Service Letter No. 186

SUBJECT: Clearance between the Engine Mount and the Exhaust Tail Pipe and  
Clearance in the Nose Wheel Steering Mechanism

MODELS AFFECTED: All Model PA-22 Airplanes

Sketch for Service Letter No. 186

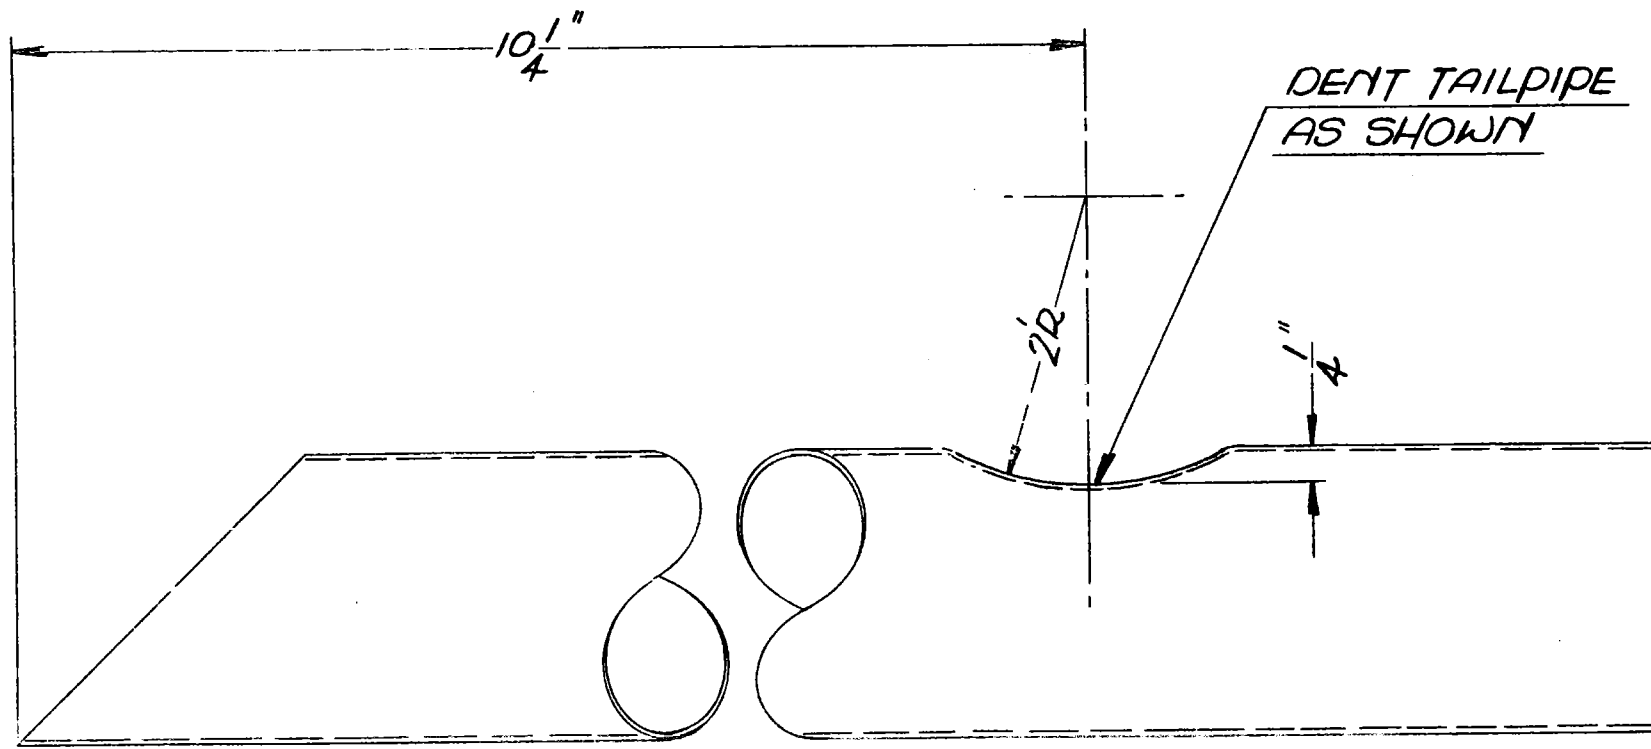
In the event it is impossible to obtain the proper clearance then the tail pipe should be modified in accordance with the attached sketch.

It has been reported that there have been cases of interference between the cross-over exhaust stacks and the nose wheel steering rod ends. We suggest that you investigate the possibility of this condition existing in your airplane and take corrective action if necessary. Proper clearances can be obtained by denting the exhaust stack tubes at the points of contact by using the same steps and dimensions as shown in the tail pipe sketch.
